ADDENDUM NO. 1

MBR TREATMENT FACILITY UPGRADE

ADDENDUM NO. 1
MBR TREATMENT FACILITY UPGRADE
REVISIONS TO CONTRACT DOCUMENTS

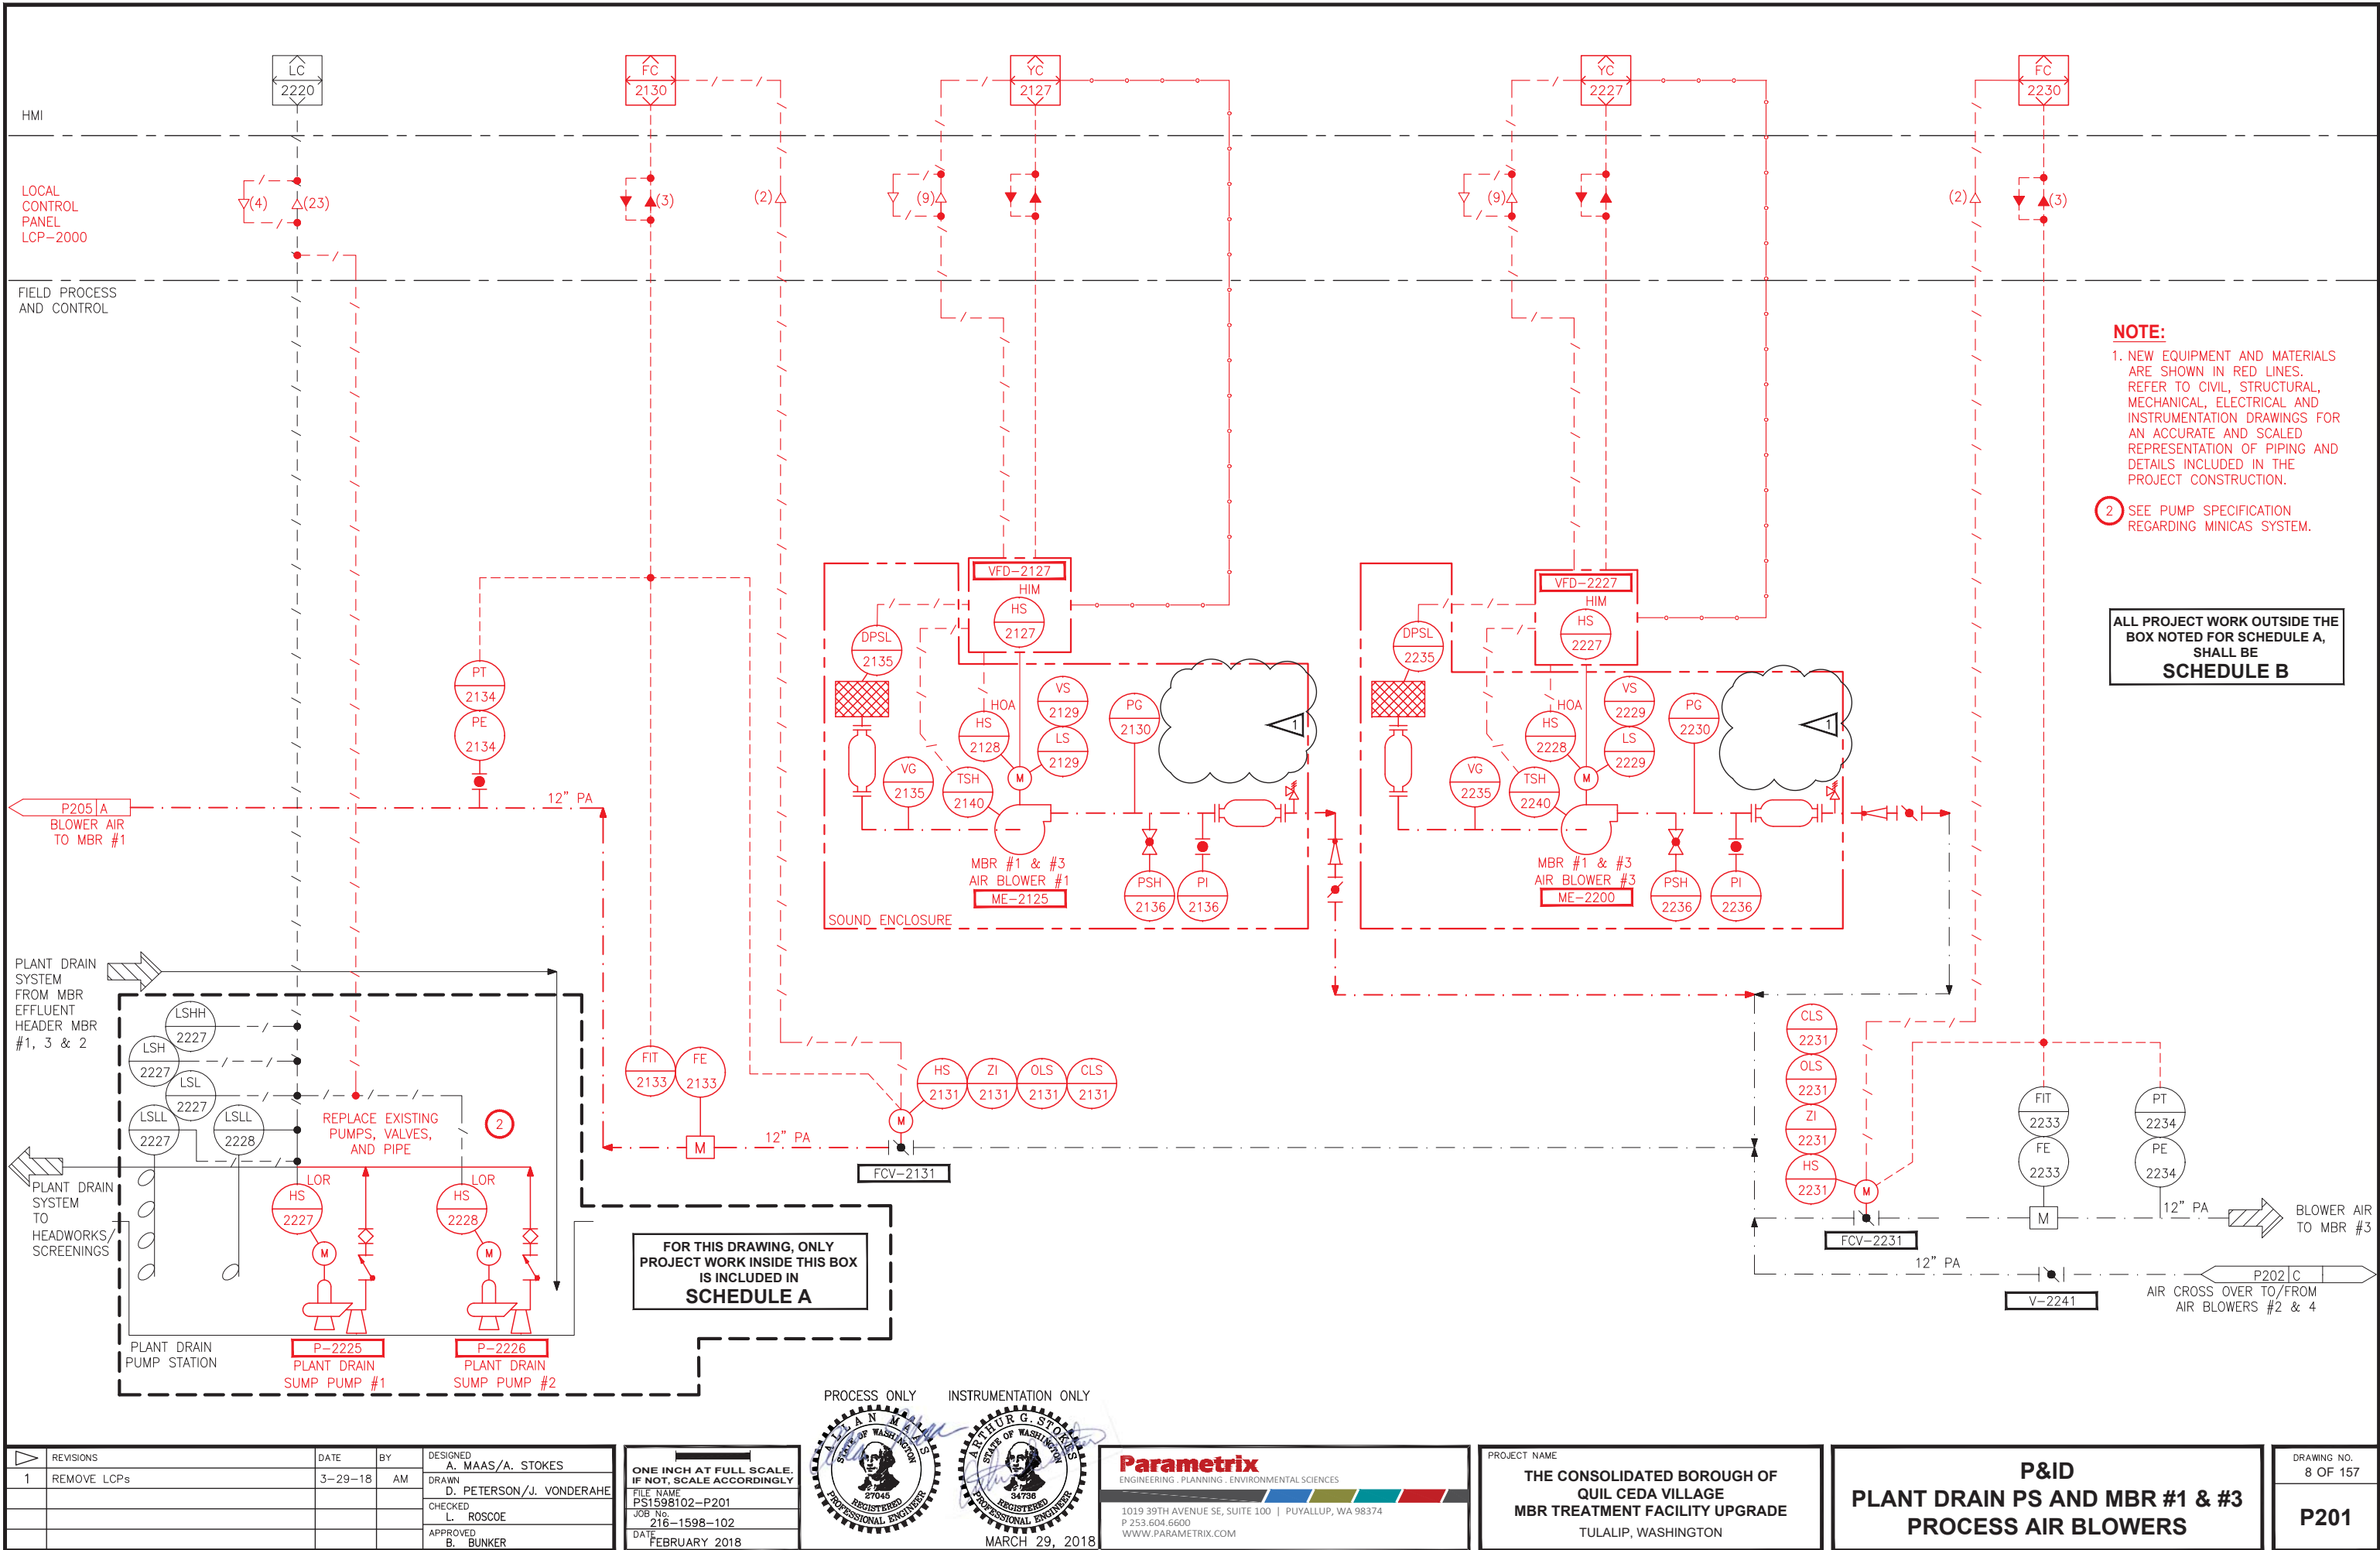
1. Program Memory: ~~2~~3 MB RAM, minimum.
2. Capable of controlling up to 30 I/O modules.
3. Online programming including runtime editing.
4. Standard RAM memory back-up provided through minimum 2-year lithium battery.
5. Memory card: Industrial SD card, 1 GB minimum.
6. LED indicators for: RUN, FORCE, I/O, OK, NS, LINK 1, LINK 2, SD
7. Three Communication Ports:
 - a. Two Ethernet port that supports Ethernet/IP protocol.
 - b. One USB.
8. Real-time clock.
9. Acceptable Manufacturer:
 - a. Allen-Bradley, CompactLogix 1769-~~L33ER~~L36ERM.
 - b. No substitutions.

I251

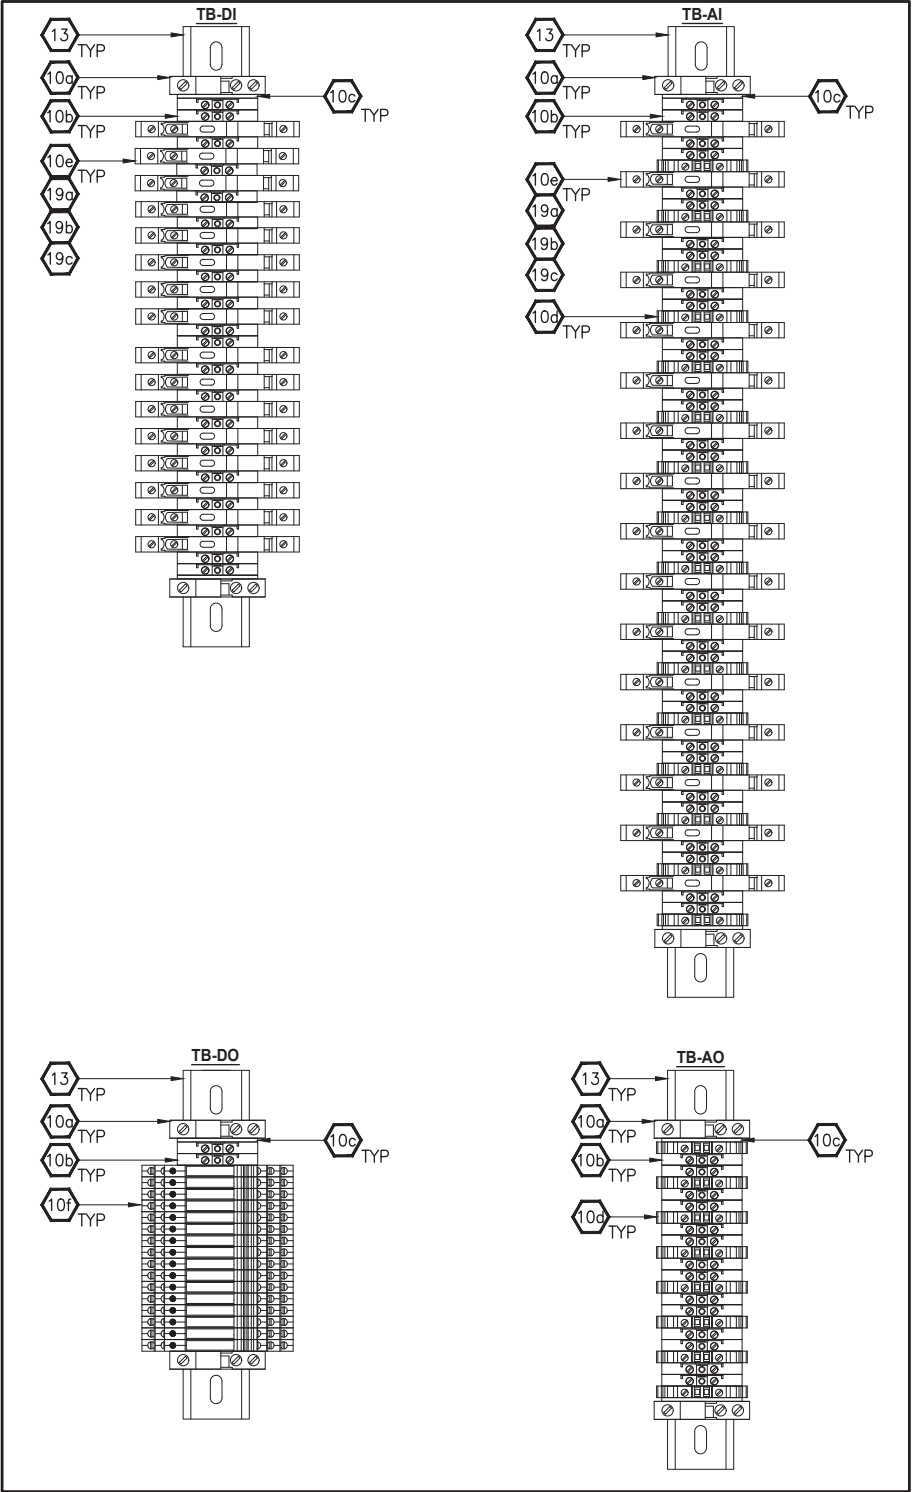
REVISIONS	DATE	BY	DESIGNED
1 PLC PROCESSOR CHANGE	3-29-18	AS	J. VONDERAHE
			J. VONDERAHE
			J. MURPHY
			B. BUNKER
